SOCIETY HILL LOCATION

SOCIETY HILL

**PROPOSED SITE PLAN
(Selected sheets –
Full submittal is available at
Community Development Department Office)**

RE: Society Hill - Revision to 1999 Final Site Plan

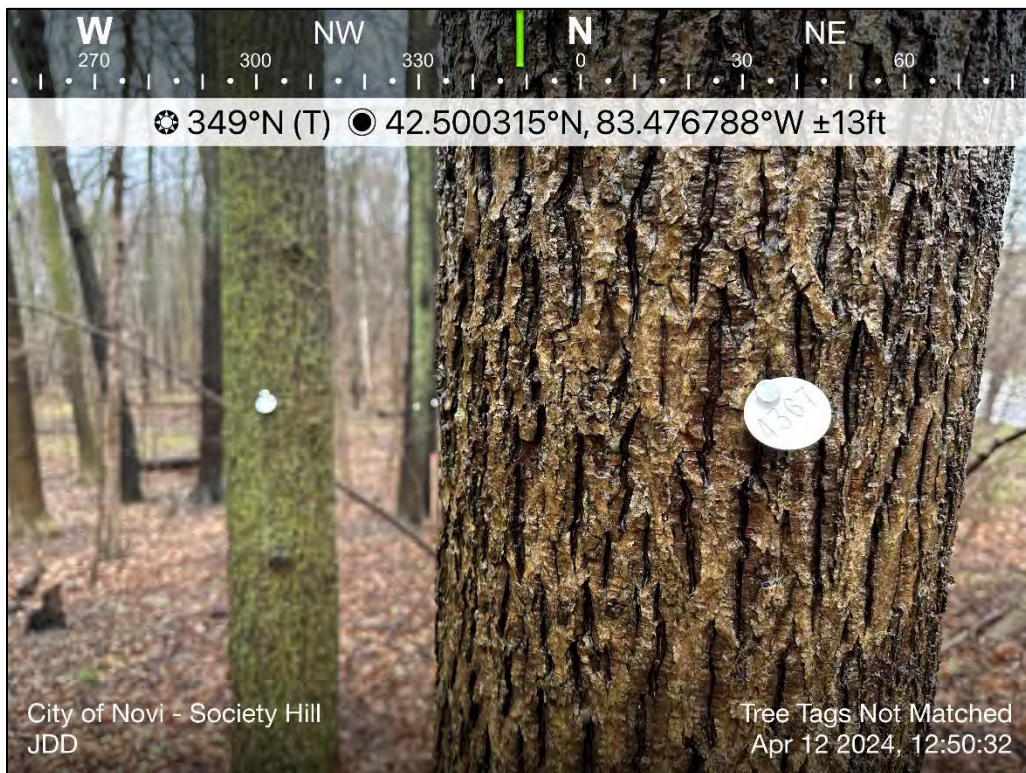
Overview of a tree tag that does not match the survey. This tree is approximately located around Tree 679 identified in the PSP. Tree tag reads as 4339.

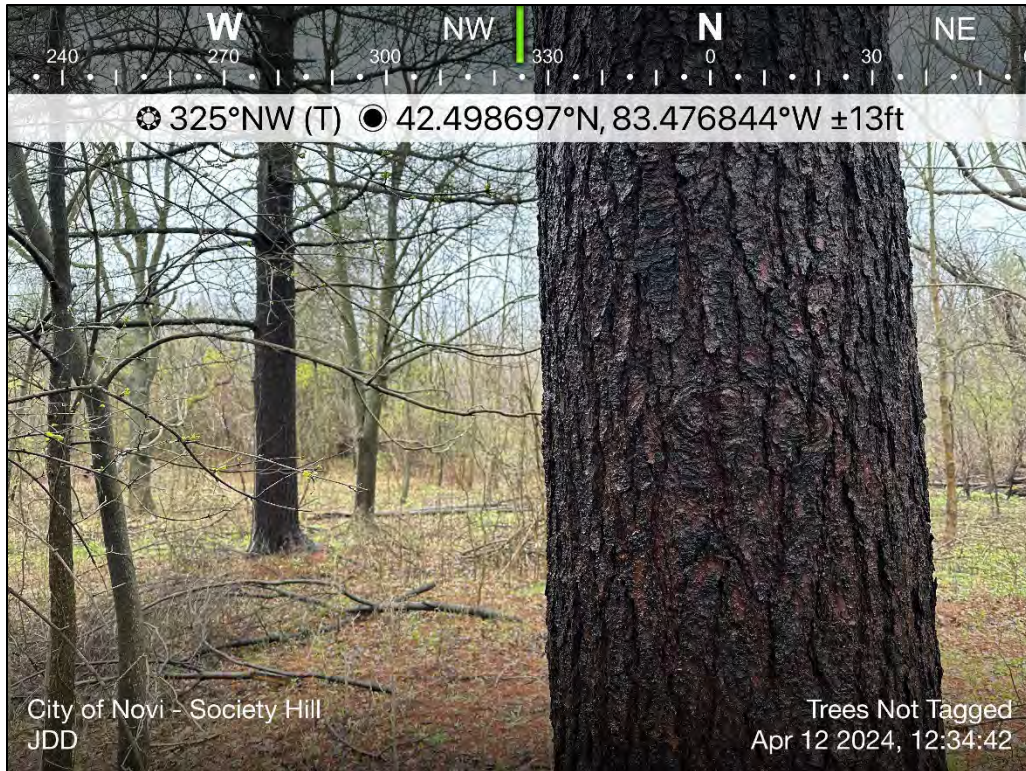
Overview of a tree tag that does not match the survey. This tree is approximately located around Tree 1104 identified in the PSP. Tree tag reads as 4367.

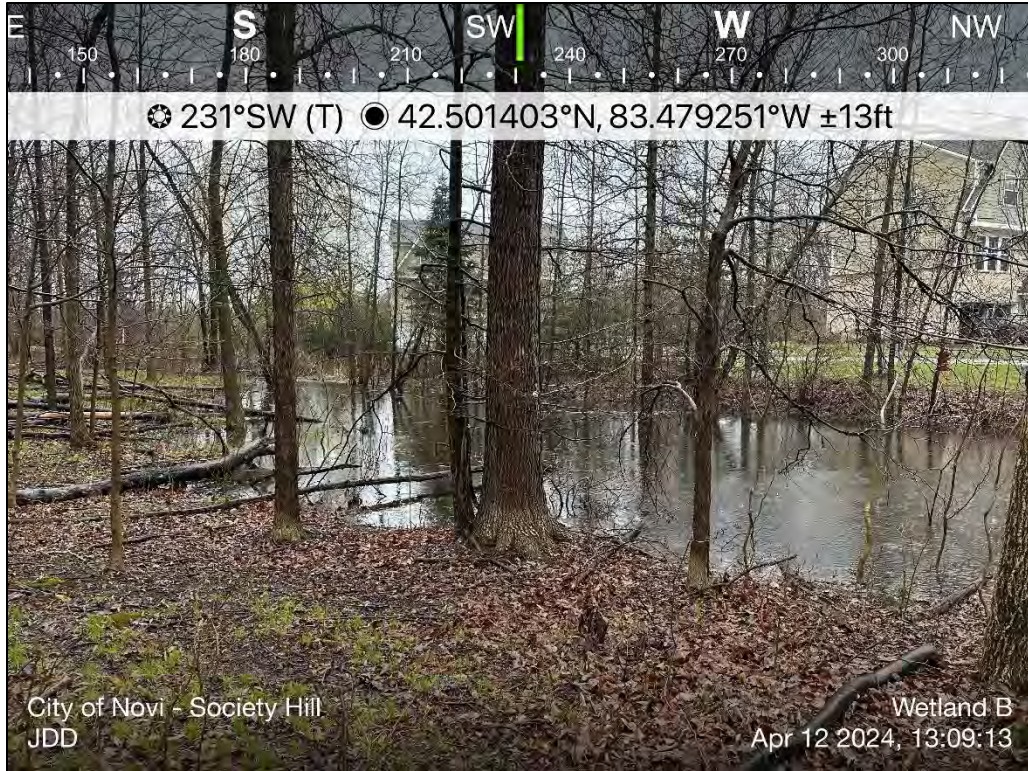
Overview of Wetland E (Wetland B on sheet two).

Overview of Wetland F (Wetland C on sheet two).

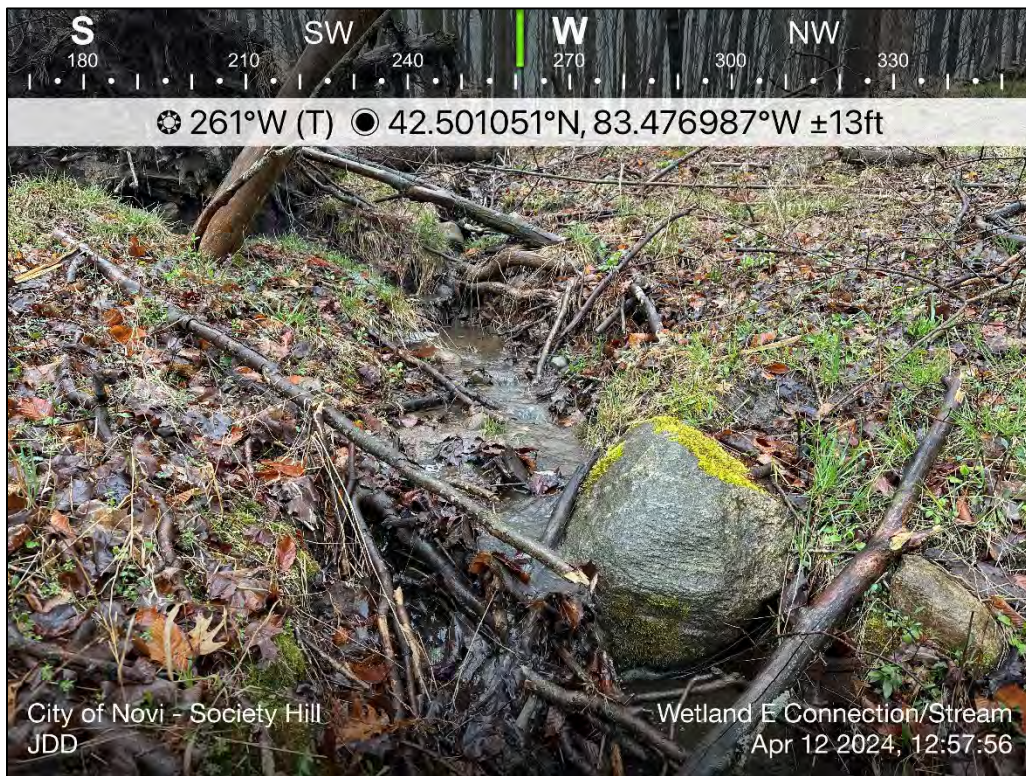
Overview of Wetland B (Wetland D on sheet two).

Overview of northern Wetland B (Wetland D on sheet two).

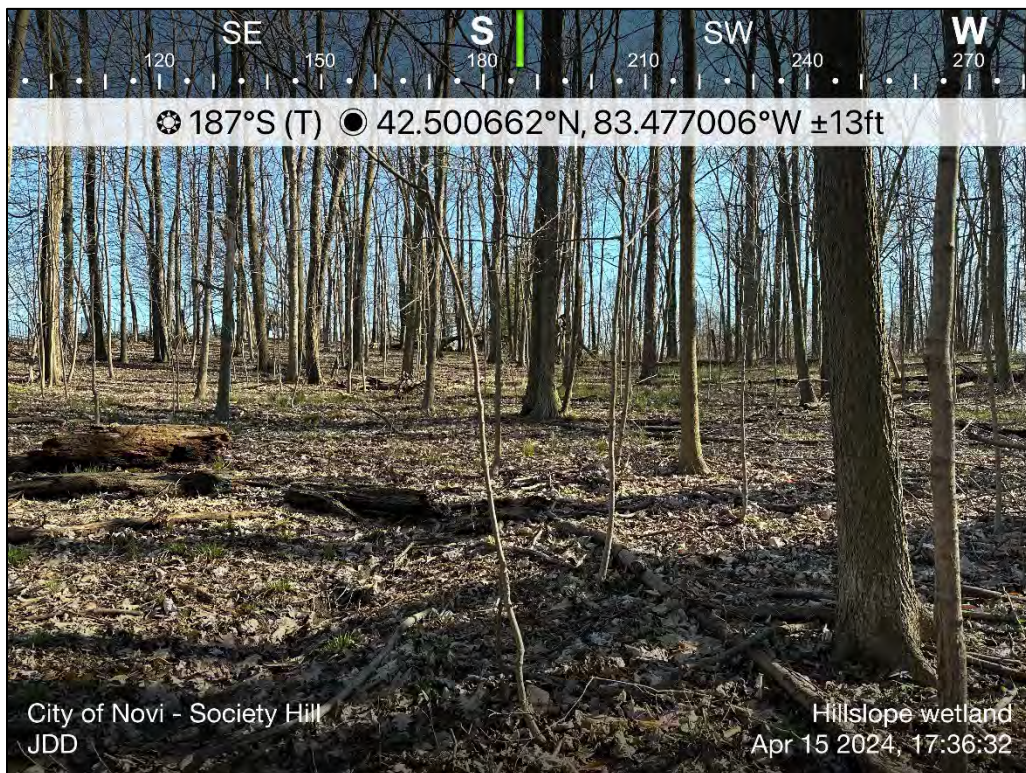
Overview of Wetland D (Wetland F on sheet two).

Overview of Wetland G, which is not identified on sheet two.

Overview of the central portion of the site. None of the trees in this area contained tree tags/markings.

Overview of Potential Missed Wetland 3.

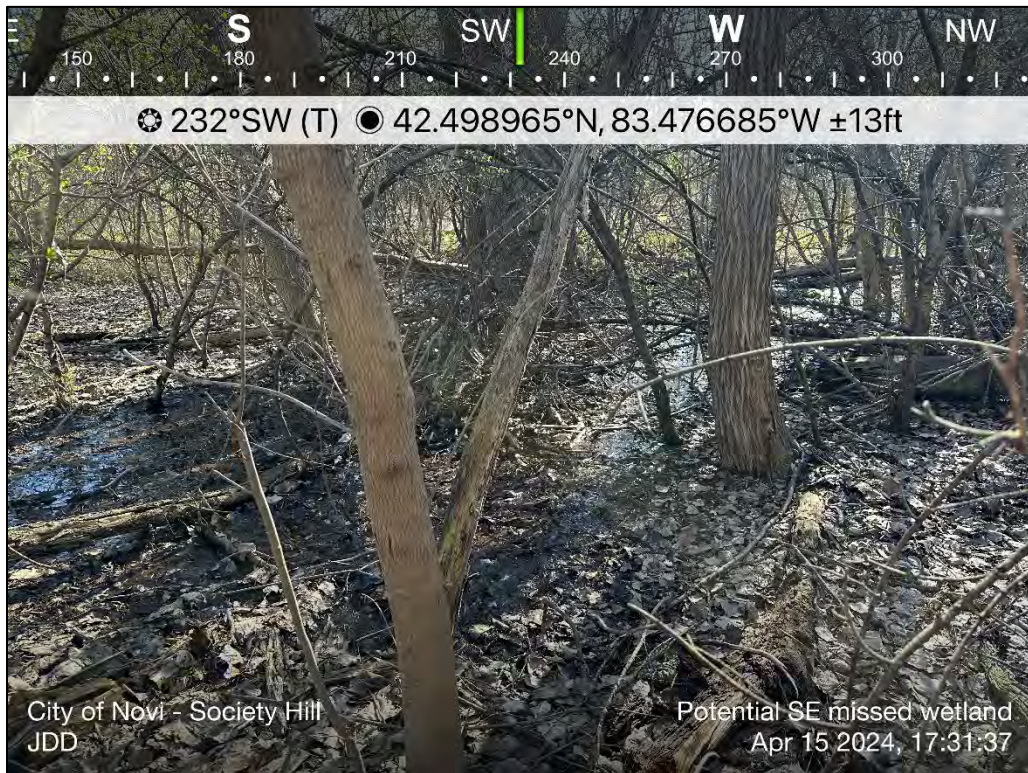
Overview of Potential Missed Wetland 1.

Overview of Potential Missed Wetland 4.

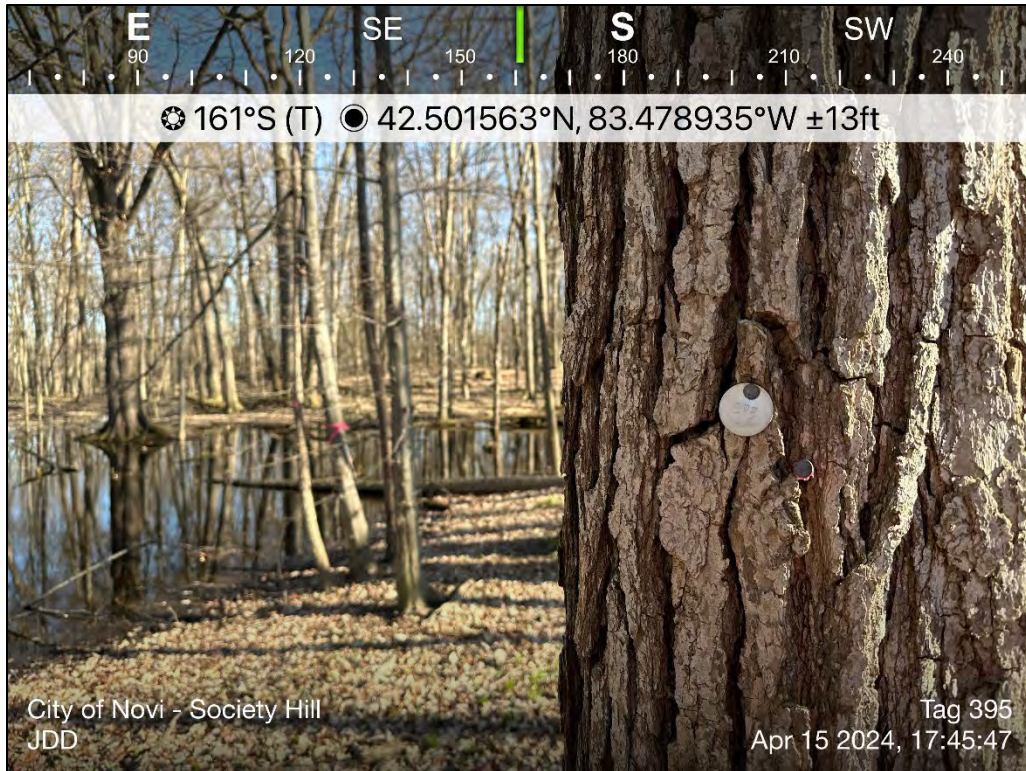
Overview of a tree tag that does not match the survey. This tree is approximately located around Tree 469 identified in the PSP. Tree tag reads as 395.

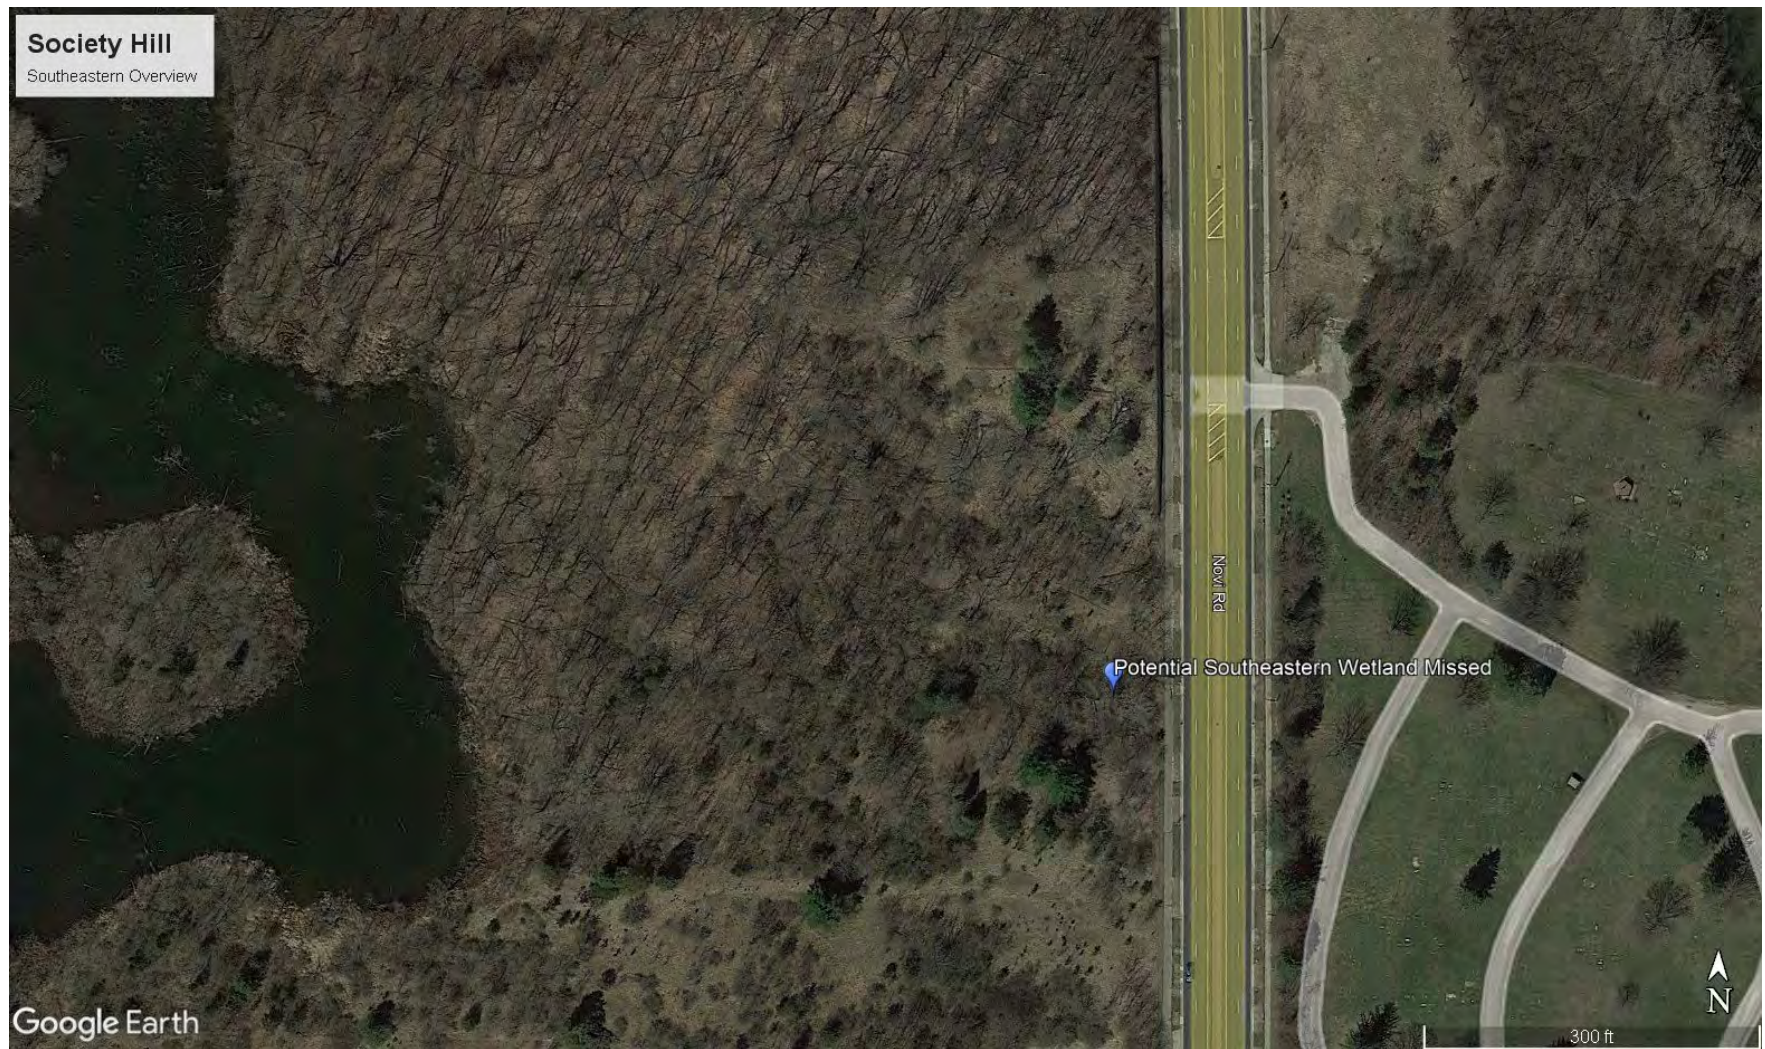
Overview of the northern portion of the site with potentially missed wetlands. Photographs of each area are included in **Attachment A**.

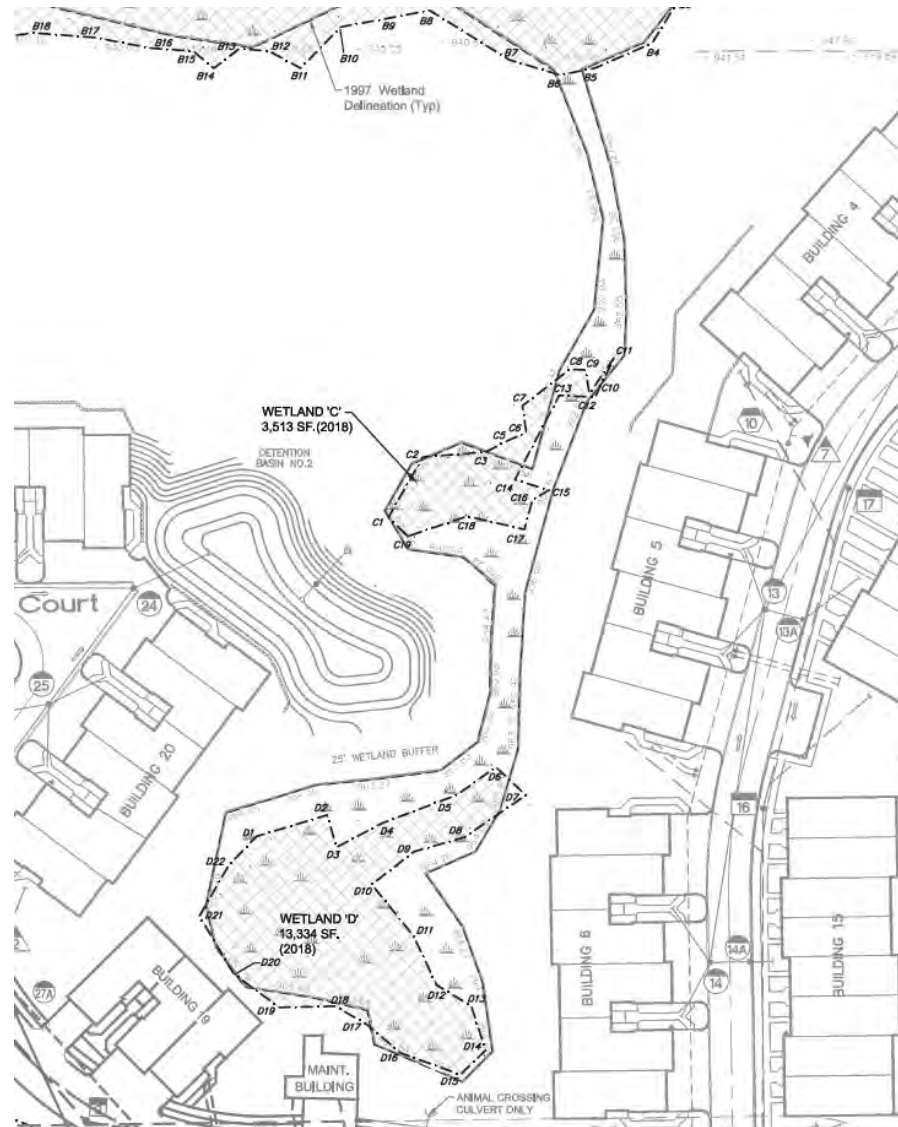
Overview of the southeastern portion of the northern parcel with a potentially missed wetland. Photographs of the area are included in **Attachment A**.
